CITY OF WACONIA PLANNING COMMISSION AGENDA

REQUEST FOR PLANNING COMMISSION ACTION

Meeting Date:	March 3 rd 2016						
Item Name:	Interlaken 8 th Addition/Stonegate Preliminary Plat, Zoning Map Amendment and Variance Applications submitted by Hartman Communities, LLC for the property located at 1150 Somerwood Drive						
Originating Department:	Planning and Zoning						
Presented by:	Lane Braaten, Community Development Director						
Previous Council Action (if any):							
Item Type (X only one):	<table border="1"><tr><td>Consent</td><td></td><td>Regular Session</td><td><input checked="" type="checkbox"/></td><td>Discussion Session</td><td></td></tr></table>	Consent		Regular Session	<input checked="" type="checkbox"/>	Discussion Session	
Consent		Regular Session	<input checked="" type="checkbox"/>	Discussion Session

The City of Waconia staff have reviewed the proposed Preliminary Plat application for the Interlaken 8th Addition/Stonegate residential development drafted by Westwood Professional Services, Inc. dated February 4th, 2016, as revised on February 22nd, 2016 and provide the following review and comments:

Date: 02/04/16 Sheet: 3 OF 8
 0007045PPP01.dwg
Preliminary Plat

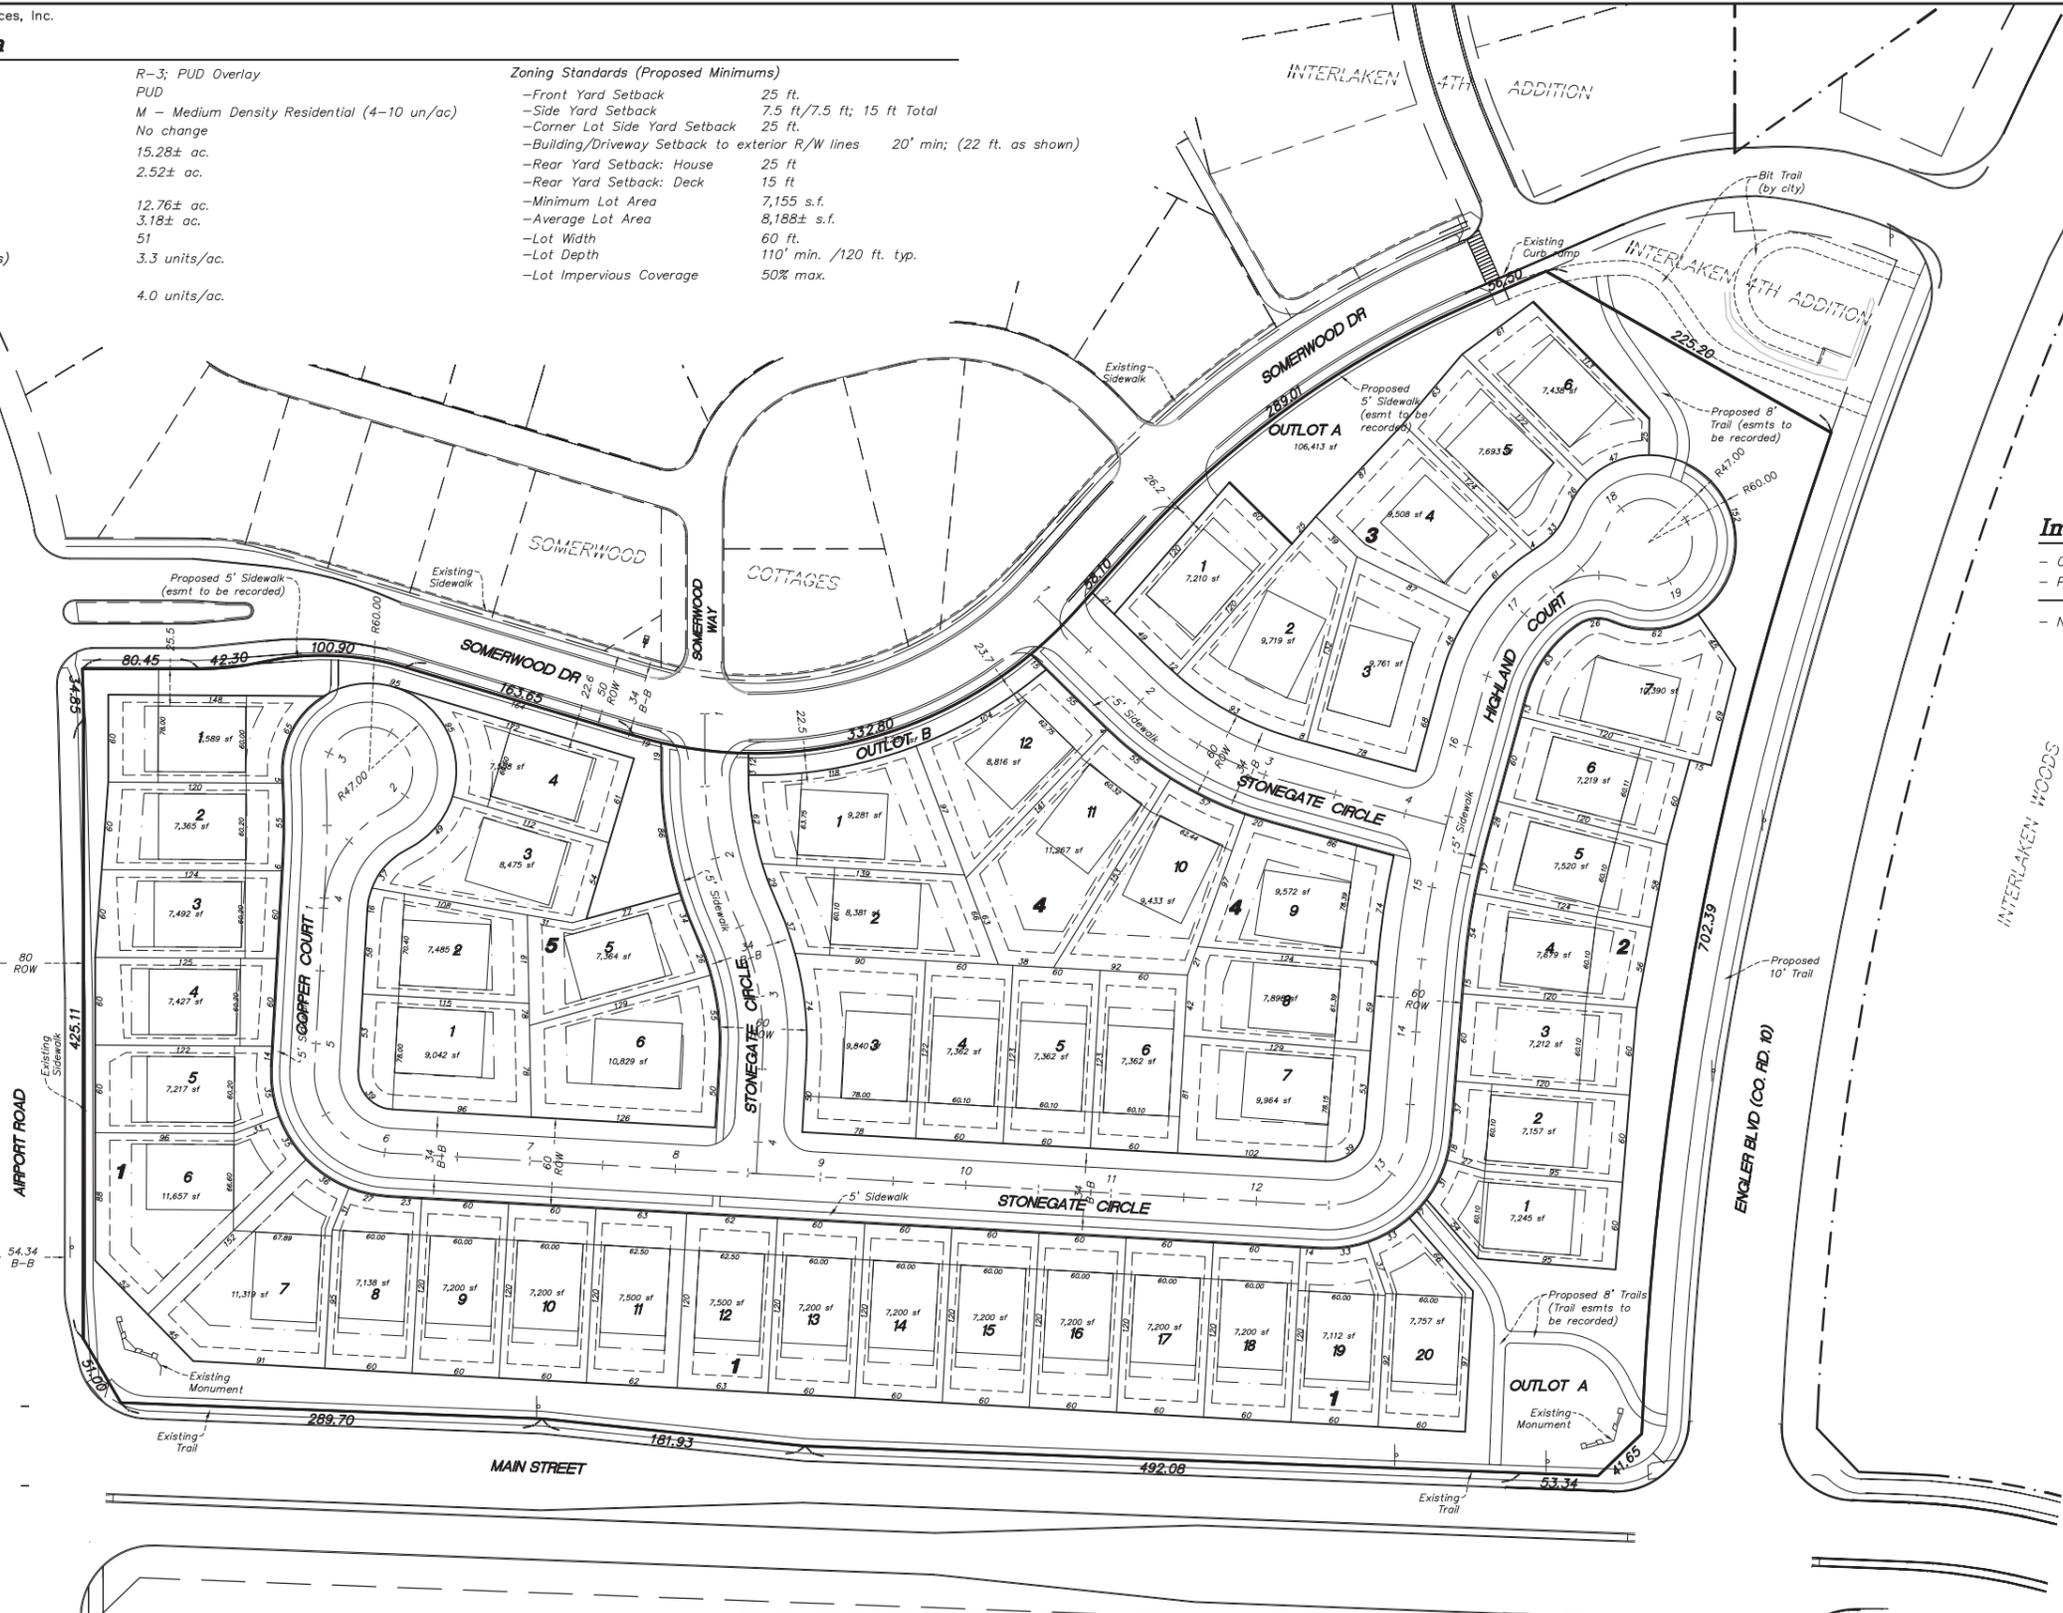
- 5) The Preliminary Plat document shall be updated to reflect the closest point of the building and parking setback from the exterior PUD property line or abutting street. The applicant has proposed a minimum setback of 20 ft., but the closest point should be reflected on the Preliminary Plat. **The PUD standards have been updated to reflect the minimum setback, and actual setback dimensions are illustrated on the preliminary plat sheet 3 as well.**

ROCK CONSTRUCTION ENTRANCE
 LAST REVISED: 03/03/08
 GD05

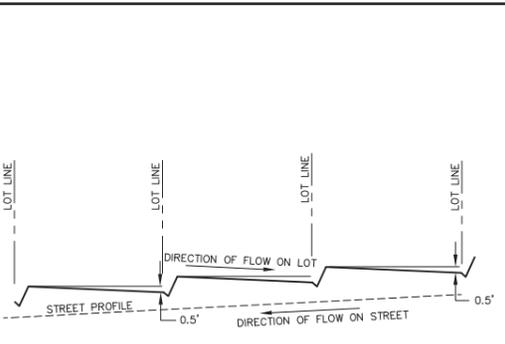
- 15) Rock construction entrances should be included at both access points to Somerwood Drive. **Plans have been revised as requested.**
- 16) The City is planning to construct the trail near the underpass at the southeast corner of this site. The proposed silt fence needs to be contained within Outlot A and coordination of construction operations / final grading in this area needs to occur. **Noted; Plans have been revised to identify this trail section as "by city" and silt fence locations have been accordingly.**

TEMPORARY BIOROLL BLANKET SYSTEM (DITCH APPLICATION)
 LAST REVISED: 03/03/08
 GD23

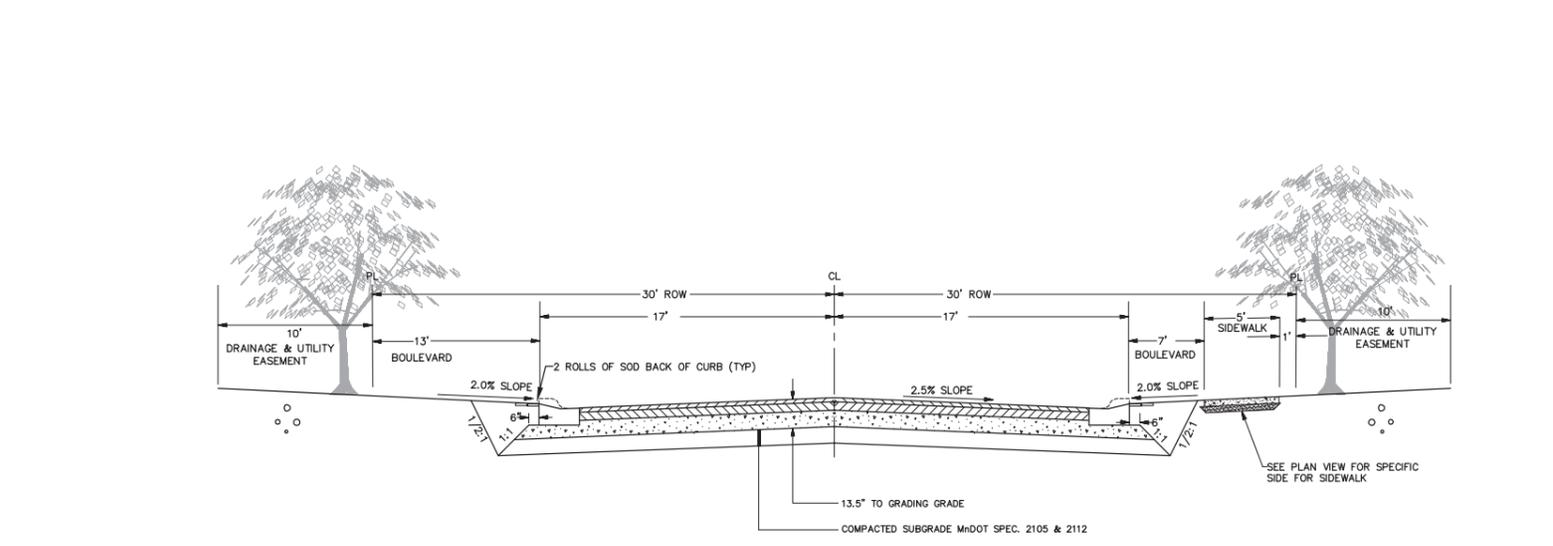
- 13) Biolog ditch checks should be included in swale areas (north side of the site). **Plans have been revised as requested.**
- 14) A minimum of a 1-foot separation should exist between the low opening of a home and the proposed EOF. The grading near the westerly EOF needs to be modified or the homes on Lot 16 and Lot 17 need to be raised. The proposed EOF route in this area needs to be clearly defined. **Plans have been revised as requested.**

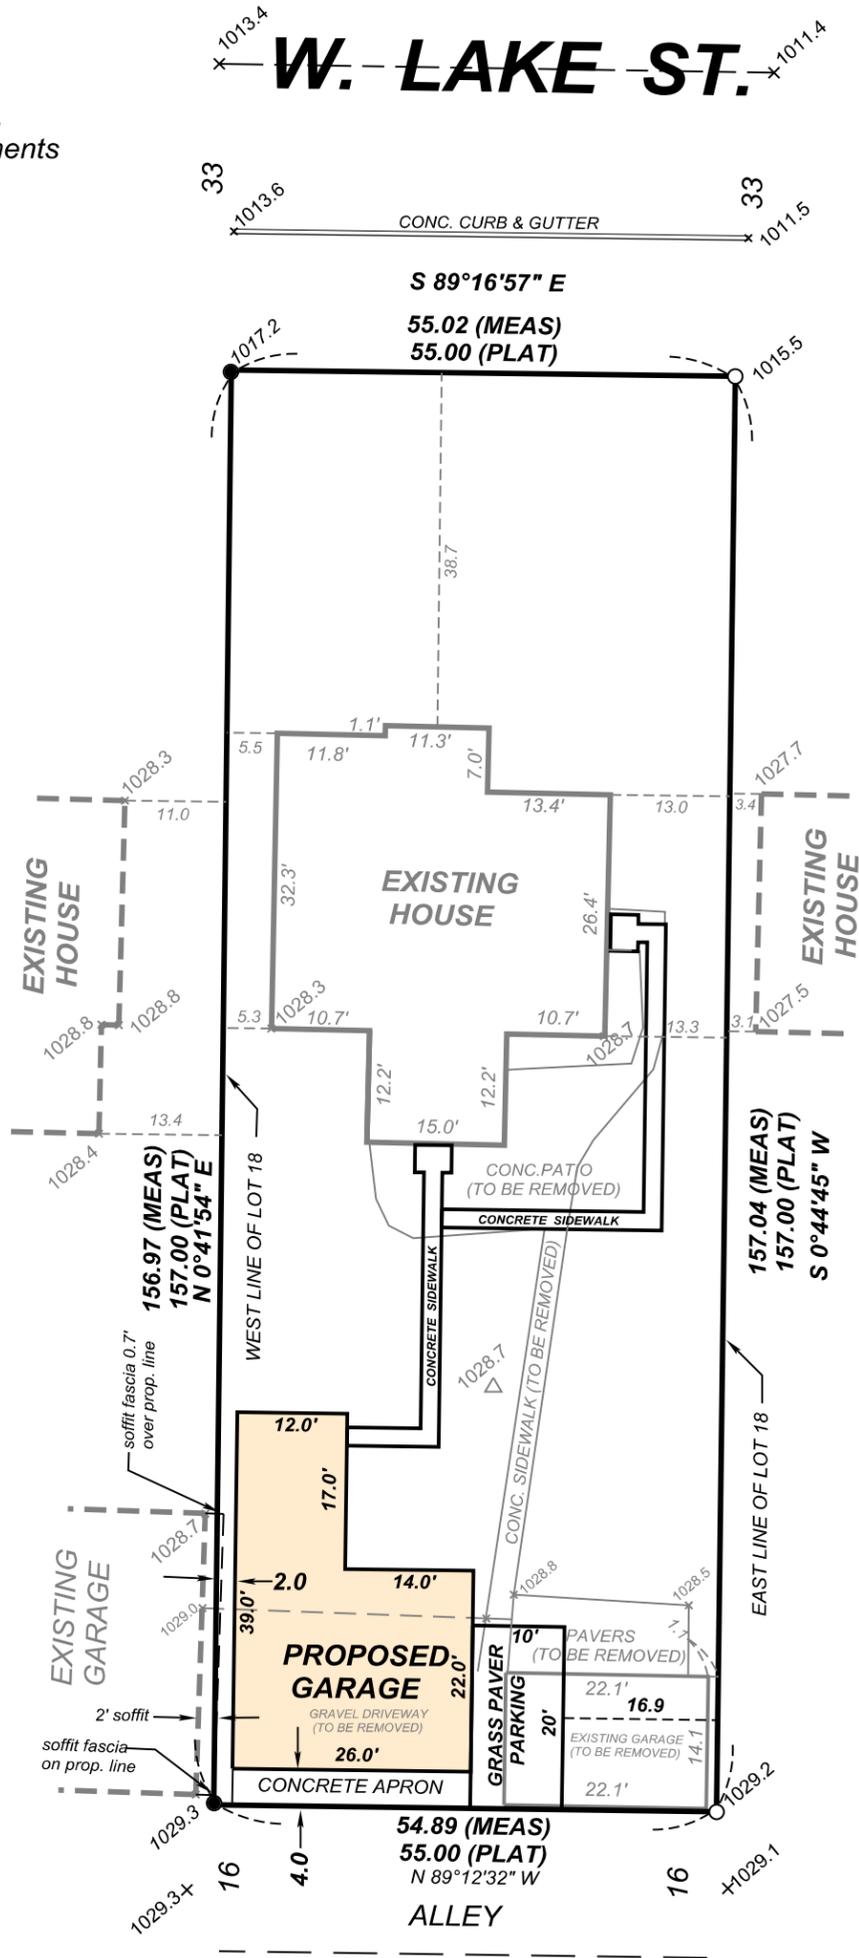
At this time, City Code does not allow a credit option for the use of permeable pavers or other alternative stormwater improvements however, recent variance applications have incorporated permeable pavers with projects that have resulted in a 25% to 50% credit when calculating impervious surface areas for sites that have had an adequate outlet for storm water drainage. The proposed plan does not have a suitable outlet and therefore no credit is being recommended. The topography of the area makes an outlet difficult. Reuse or irrigation could be considered which would result in a partial credit.

The proposed 4 ft. setback to the south (towards the alley) is not recommended. Assuming the garage doors face south the turning movement from a 16 ft. wide alley into the garage is problematic. Also, the alley snow removal operations would push snow either into the garage or up against the garage door. The 10 ft. setback width should be maintained or the site should be modified for the garage doors to face to the east.
